AMENDMENT NO. 2 NOVEMBER 2024

IS 16988 : 2018 COMPRESSED NATURAL GAS CYLINDER VALVE INTEGRATED WITH SOLENOID OPERATION (REMOTELY CONTROLLED) FOR AUTOMOTIVE USE — SPECIFICATION

ENLARGED DETAIL AT X

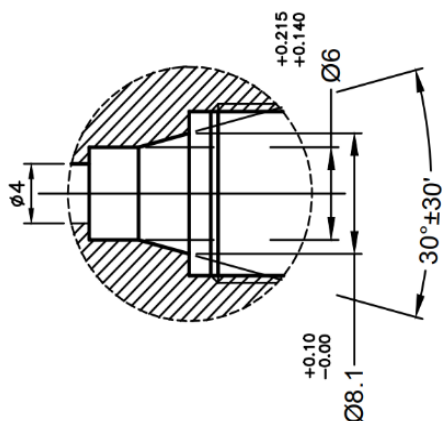
(Page 14, Outlet No. 21A) — Substitute the existing 'ENLARGED DETAIL AT X' by the following 'ENLARGED DETAIL AT X':
